# Rockwell service bulletin

No. SB-AG-11

### INSPECTION AND/OR REPLACEMENT OF AILERON HINGE BRACKETS

MODELS AFFECTED: MODEL S-2R, SERIAL NOS. 1416 THRU 2491  
5000 THRU 5100  
MODEL S2R-T34, SERIAL NOS. 6000 THRU 6007 REVISED 10-20-78

Figure 1.

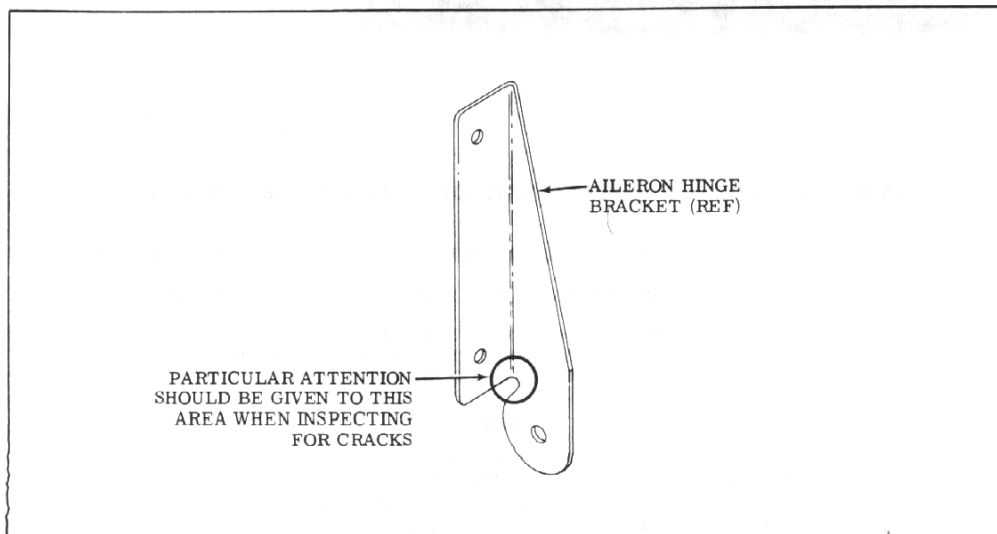
1. Visually inspect all aileron hinge brackets in area shown in Figure 1. For possible cracks.
2. If no cracks are evident, proceed to step 10. Of Part I.
3. If cracks are found, remove applicable aileron from airplane as outlined in the Airplane Maintenance Manual, Section VII.
4. Cut a 1.50-inch diameter hole (as necessary) in lower aileron skin in order to gain access to aileron hinge bracket attaching nuts (see Figure 2.).
5. Remove and replace cracked aileron hinge brackets as necessary.

Figure 2.

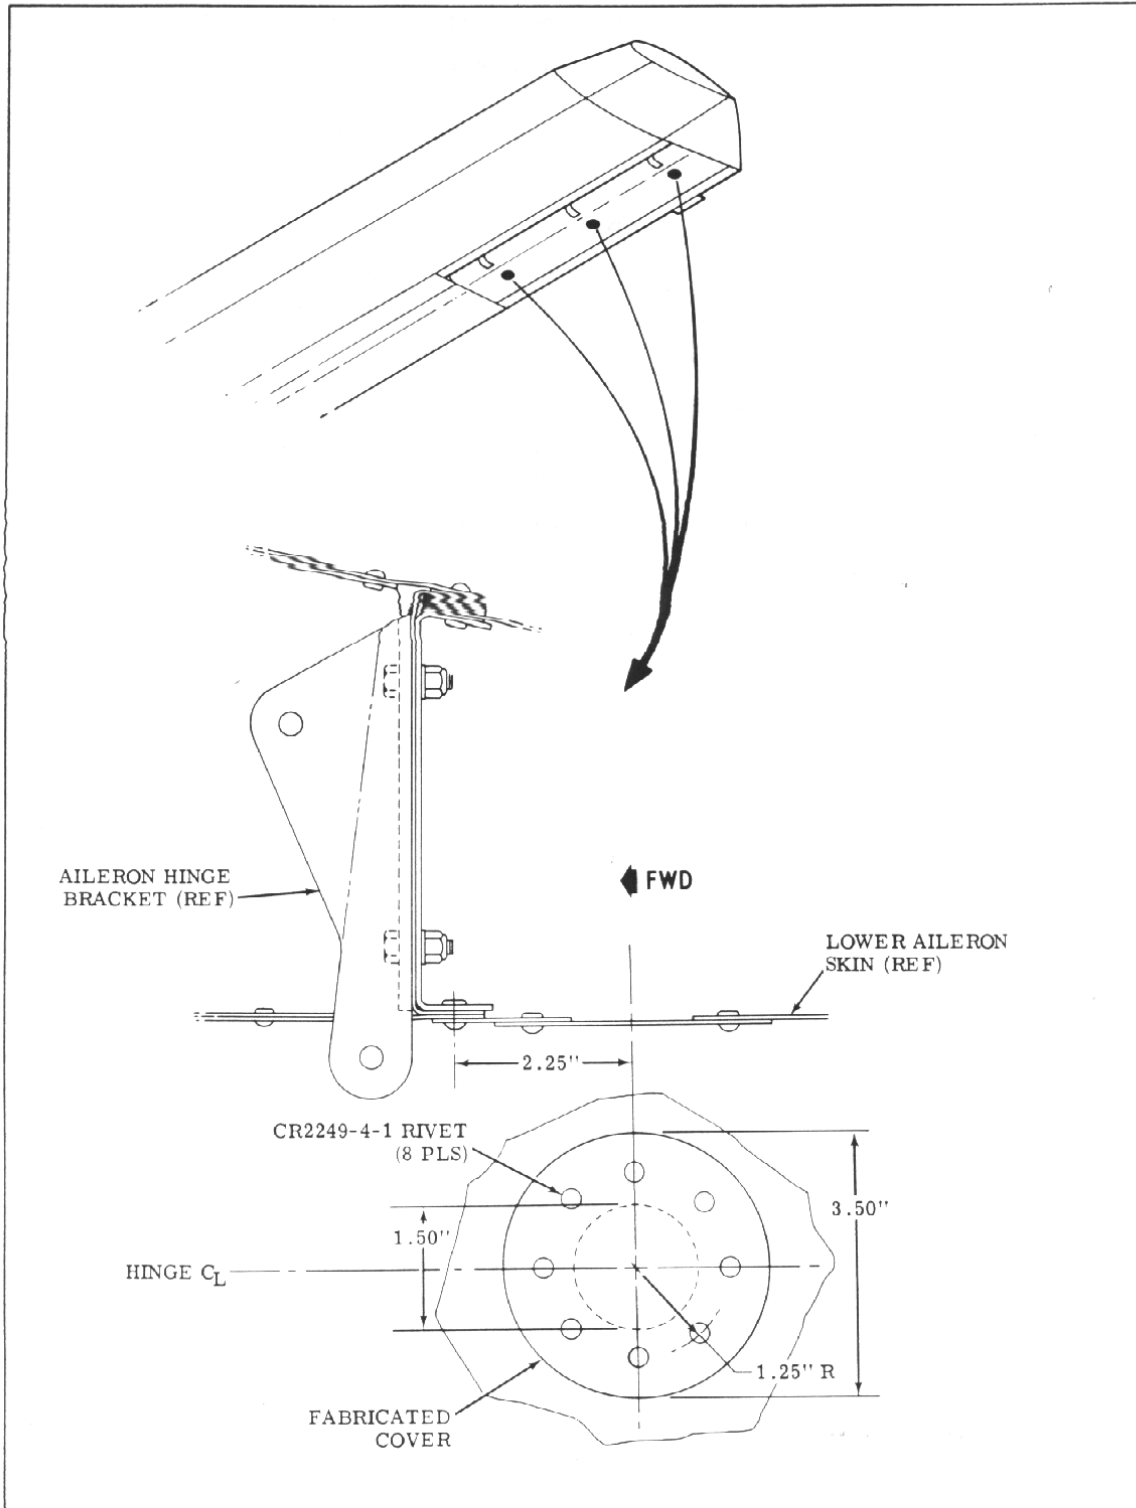
6. Fabricate a cover as shown in Figure 2. from 2024-T3 aluminum sheet stock.

Thickness of cover to be same as aileron skin.

7. Install cover, fabricated in step 6., using CR2249-4-1 blind rivet (8 places) (see Figure 2.).
8. Repaint area, as necessary, as outlined in the Airplane Maintenance Manual in Section II, entitled "CORROSION CONTROL".
